WURLITZER SERVICE SLANTS

SUBJECT: All -4 and -7 3500, 3510 and 3560 Series Phonographs shipped from the Factory prior to the following Serial Numbers:

FIGURE 1

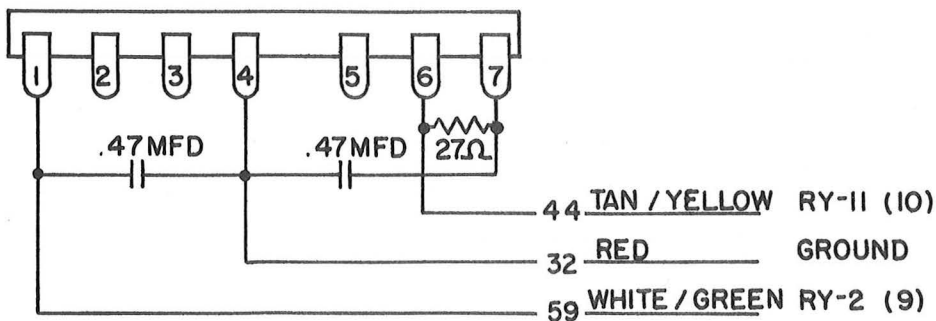
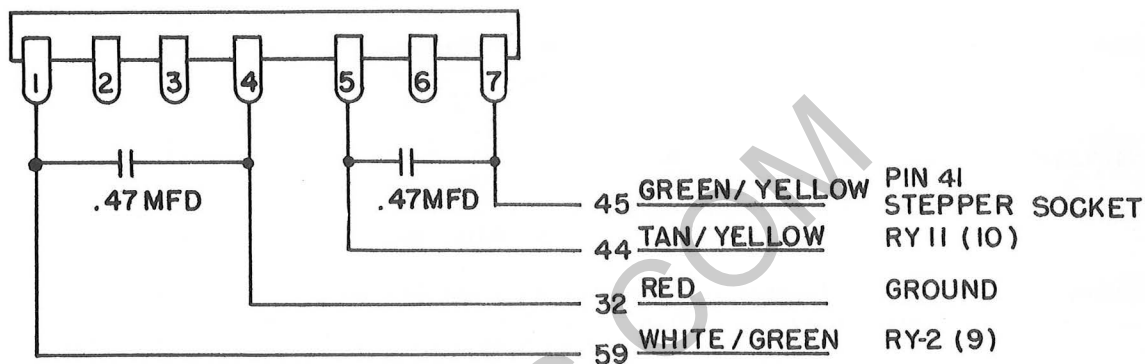
1. Play Counter hanging up on half cycle.
2. On Phonographs equipped with 4 Quarter Credit Accumulator, Dollar Relay (RY-44) may not release causing an additional four credits to be established on Playrak.

CAUSE: High resistance path through Play Counter and arc-suppression circuit for Cancel Solenoid was providing low voltage of sufficient magnitude to keep Dollar Relay (RY-44) activated allowing an additional four credits to be established through the 75 Cent Coil. This path also provided current of sufficient magnitude to hang up Play Counter.

REASON FOR CHANGE: To eliminate the low voltage on the Dollar Relay (RY-44) and the erroneous current flow through the Play Counter thus providing proper operation of Credit Accumulator and Play Counter.

1. Unsolder and remove the 27 ohm Resistor located between terminals 6 and 7 as shown in Figure 1. Discard Resistor.

2. Unsolder and remove Tan/Yellow wire from Terminal 6, shown in Figure 1, and connect this wire to terminal 5 as shown in Figure 2. Do not solder at this time.
3. Remove lead of .47 mfd Capacitor connected between terminals 4 and 7, as shown in Figure 1, from terminal 4. A Red Wire and another .47 mfd Capacitor lead are also connected to this terminal. Do not remove these.
4. Connect lead of .47 mfd Capacitor, removed in Step 3, to terminal 5 as shown in Figure 2. Solder capacitor lead and Tan/Yellow wire connection.

5. Connect a suitable length of 22 A.W.G. wire, Green/Yellow, between .47 mfd Capacitor (terminal 7) and Pin 41 of Stepper Socket. Solder both connections.

This wiring change places the .47 mfd Capacitor directly across the Cancel Solenoid circuit (44-45).
